Re: **SCI-823-6.81, Portsmouth Bypass Project, PID 19415**
Addendum to Report: Lucasville-Minford Road (CR 28) Interchange
Embankment Stability, Time-Rate of Consolidation, Soil Cut Slope Stability, and Subgrade
Treatment
DLZ Job No.: 0121-3070.03, Document No. 108

DLZ has reviewed ODOT-Office of Geotechnical Engineering's (OGE's) Stage I review comments (dated January 31, 2007) for Phase I of the SCI-823 project. In compliance with the review comments, DLZ has modified the slope stability analyses and time-rate of consolidation calculations for the Lucasville-Minford Road (CR 28) interchange embankments. This document also presents recommendations for soil cut slopes, and subgrade treatment for the interchange mainline roadway and ramp alignments contained within the interchange.

TIME-RATE OF CONSOLIDATION CALCULATIONS

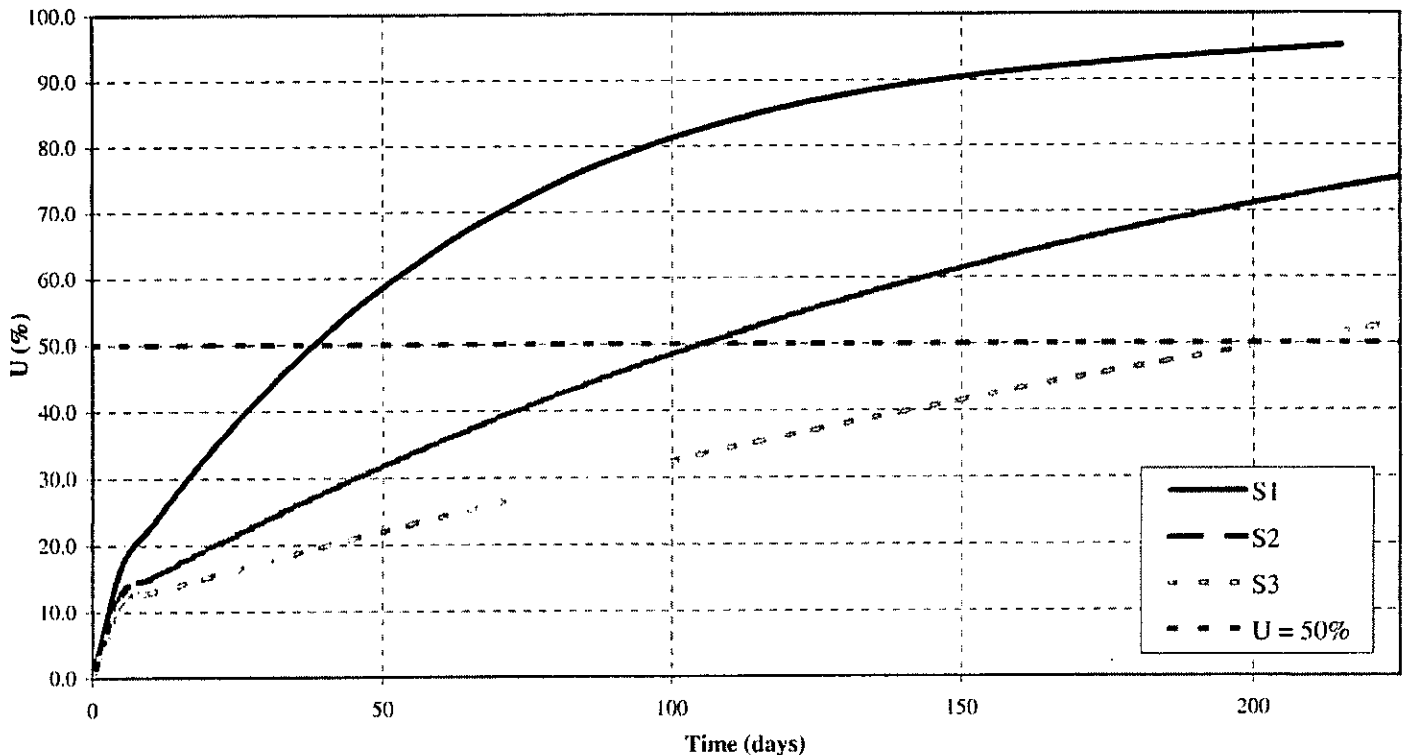
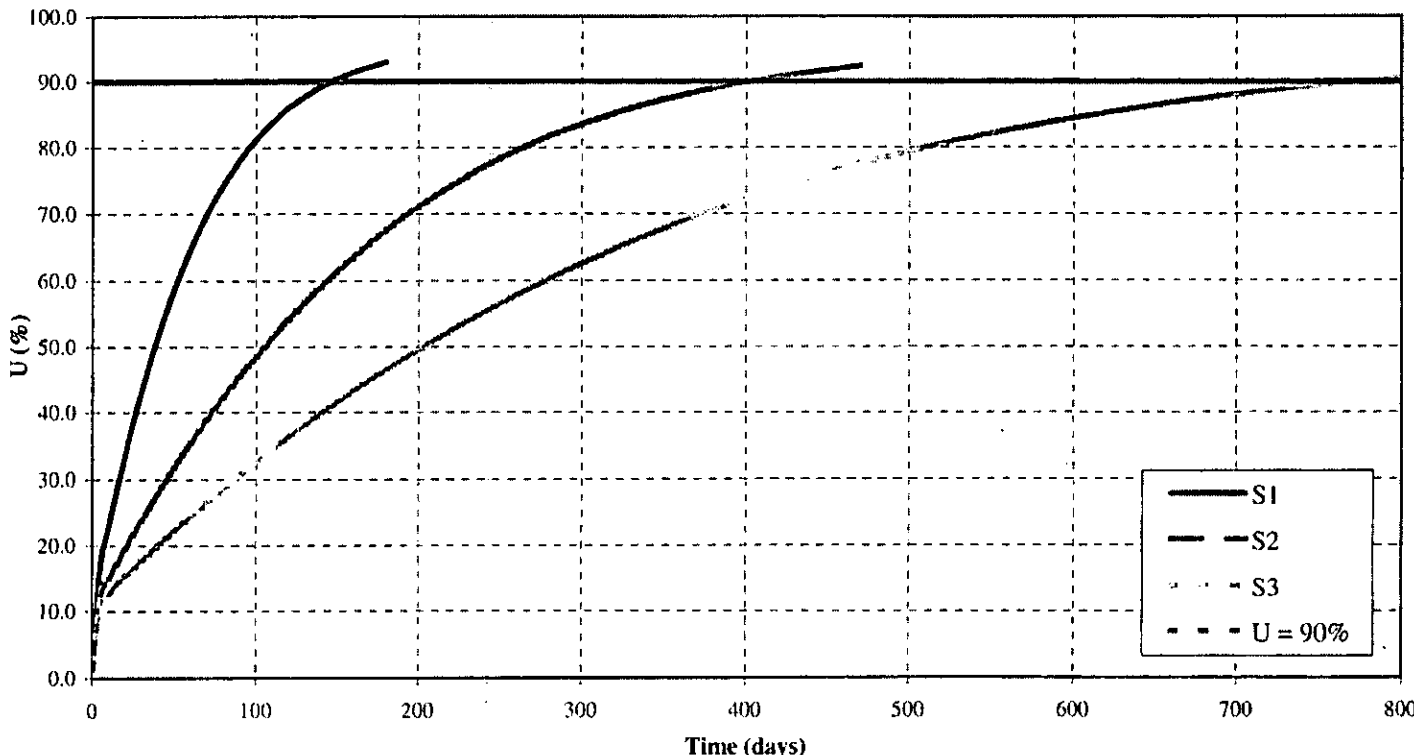
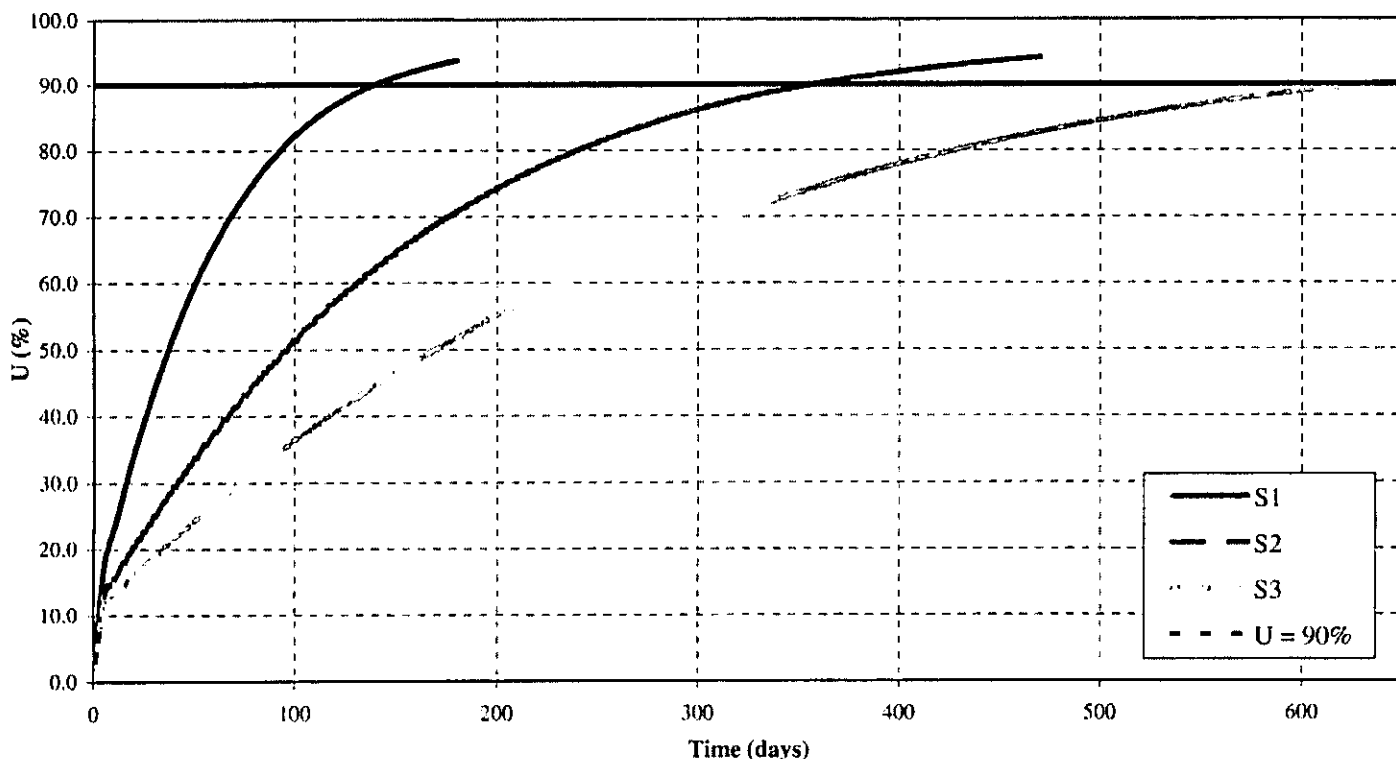
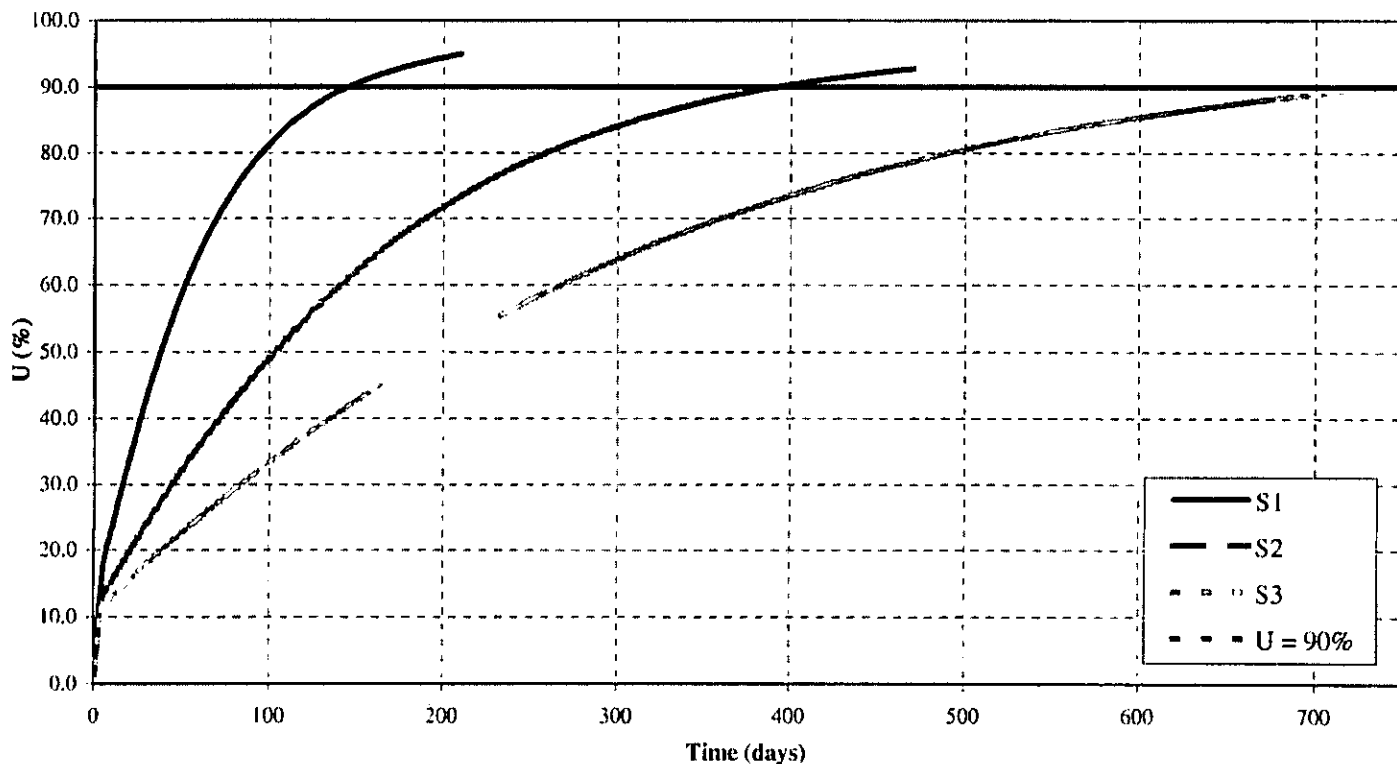
- OGE requested that DLZ use a standard degree of consolidation of ninety percent when citing consolidation times instead of eighty percent.
- OGE suggested that when estimated settlements are in excess of 24 inches, pavement preparation should not commence until at least ninety percent of primary consolidation has occurred.

The time-rate of consolidation calculations were modified based upon the “benchmark” time-rate of consolidation of ninety percent instead of eighty percent. Various wick drain spacing options and the associated consolidation times are also presented. The results of the calculations are presented in the following paragraphs.

As mentioned above, after constructing the stage 1 embankment, fifty percent of consolidation (U=50%) should be achieved prior to placing the subsequent stage. The estimated consolidation times are presented in the following table. It should be noted that these consolidation times are estimates only. The ODOT construction representative should determine when the specified degree of consolidation has occurred based upon settlement and piezometer measurements in the field.

WICK DRAIN AND INSTRUMENTATION PLAN
C.R. 28 / SR 823 INTERCHANGE

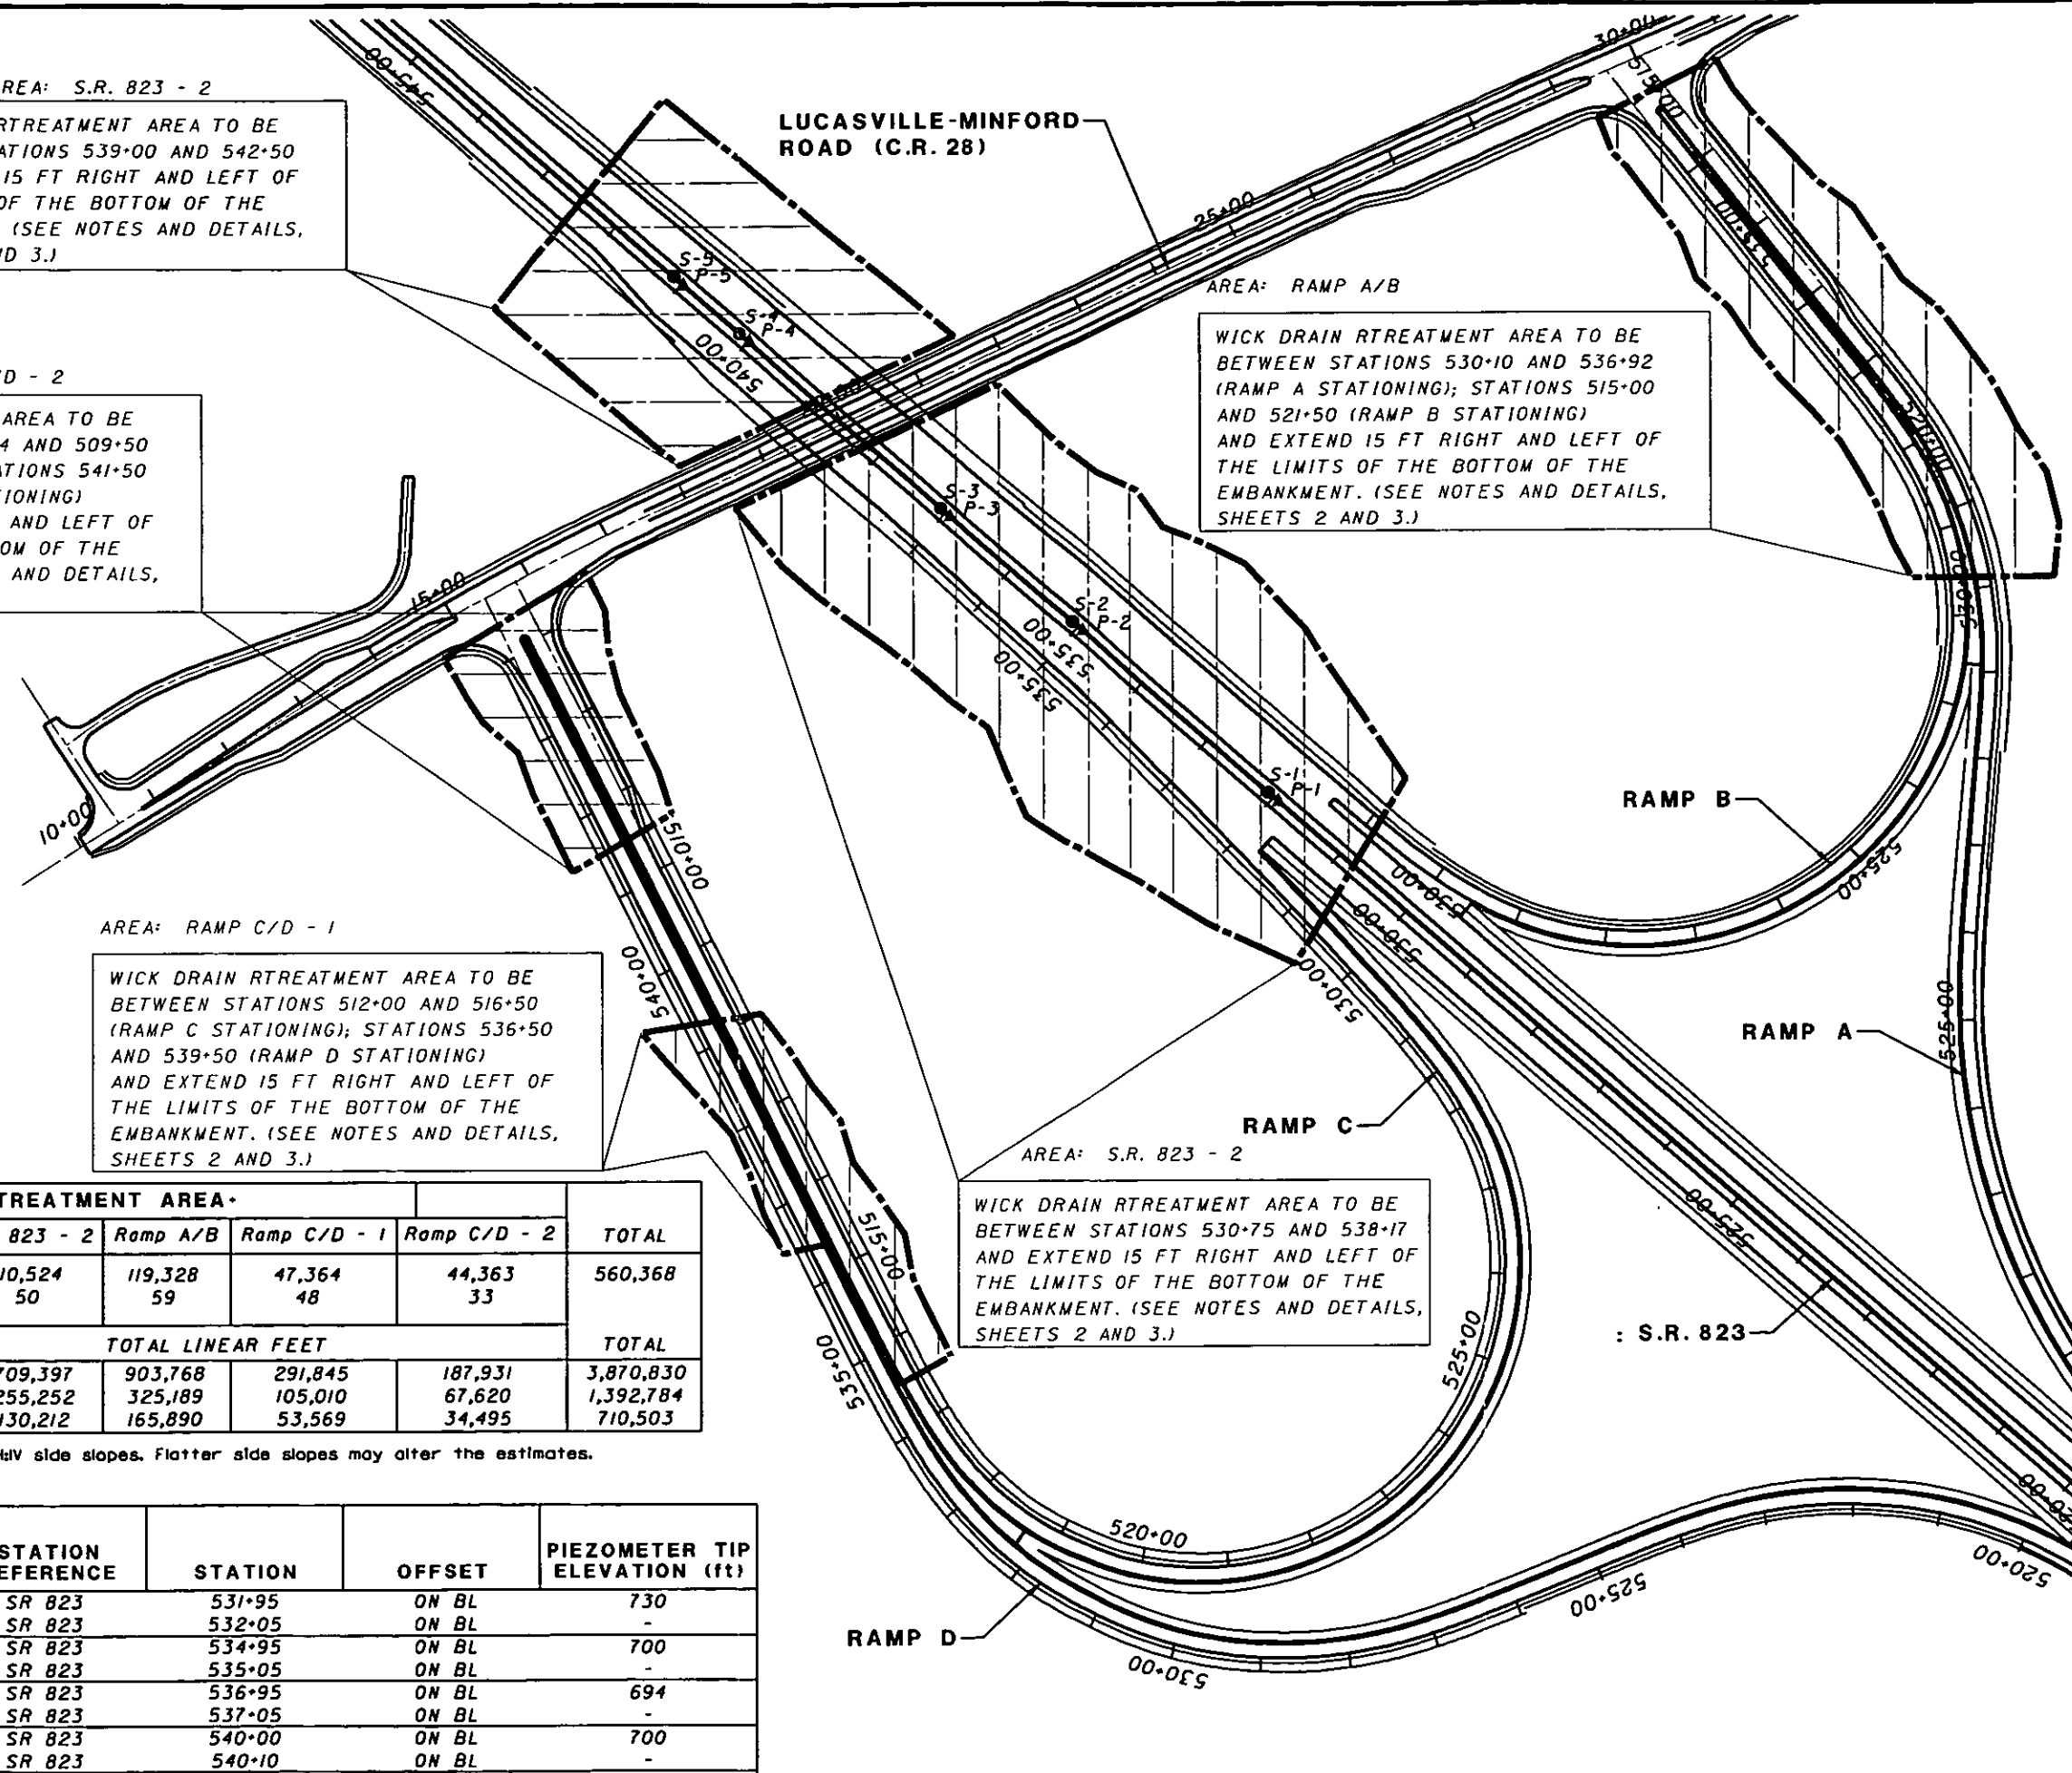
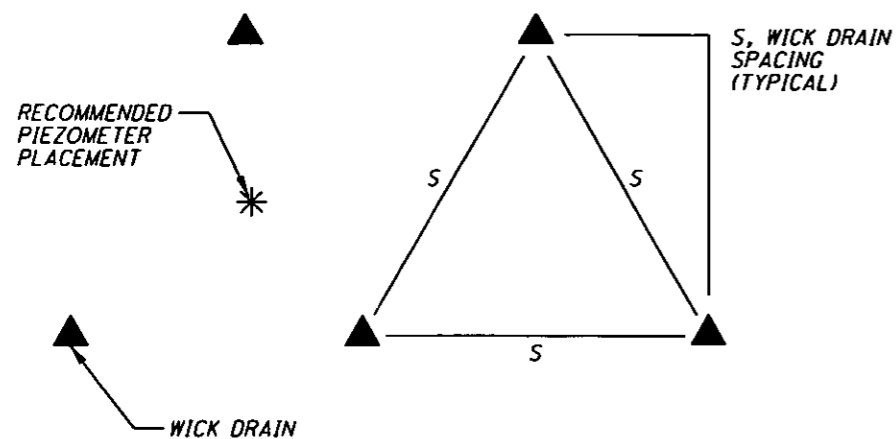
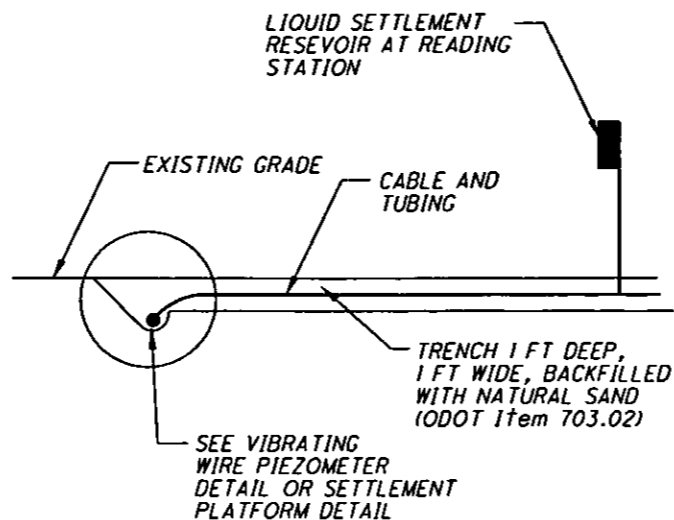
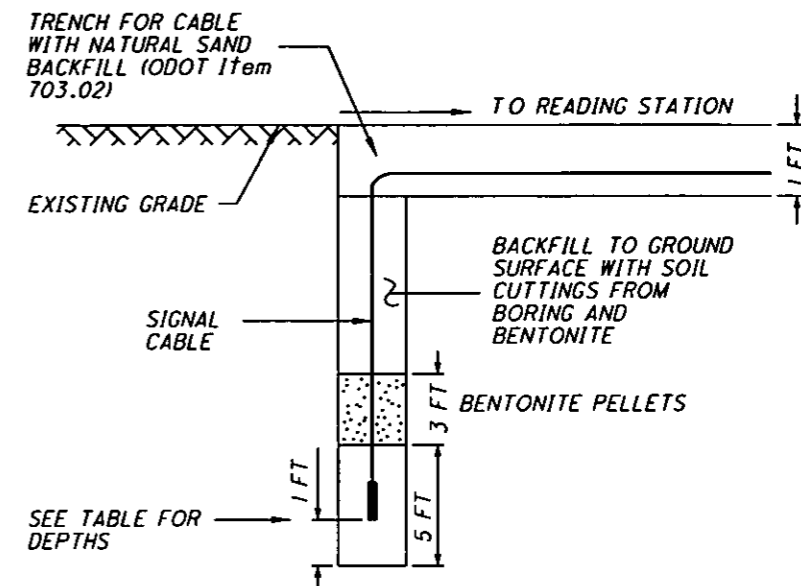
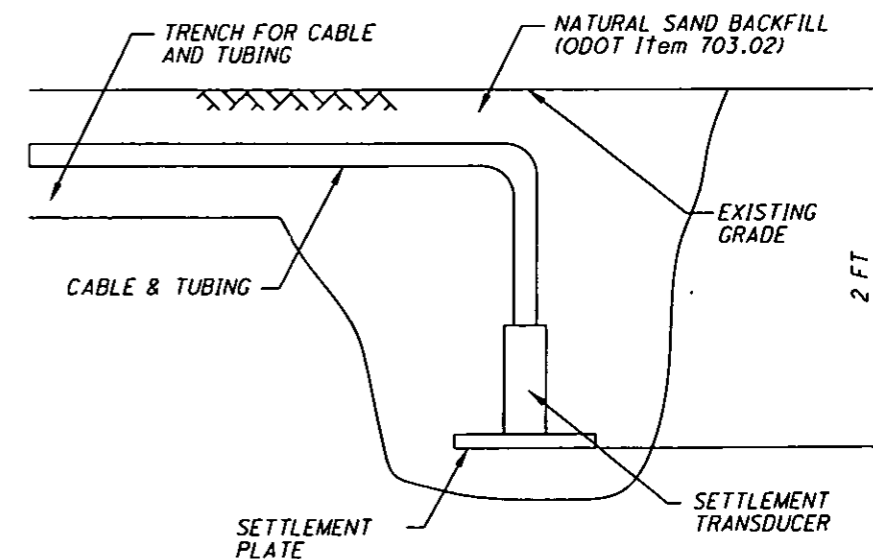
Due to changes in the time-rate of consolidation calculations and the addition of alternate wick drain spacing options, an update of the wick drain and instrumentation plans for the interchange are attached.
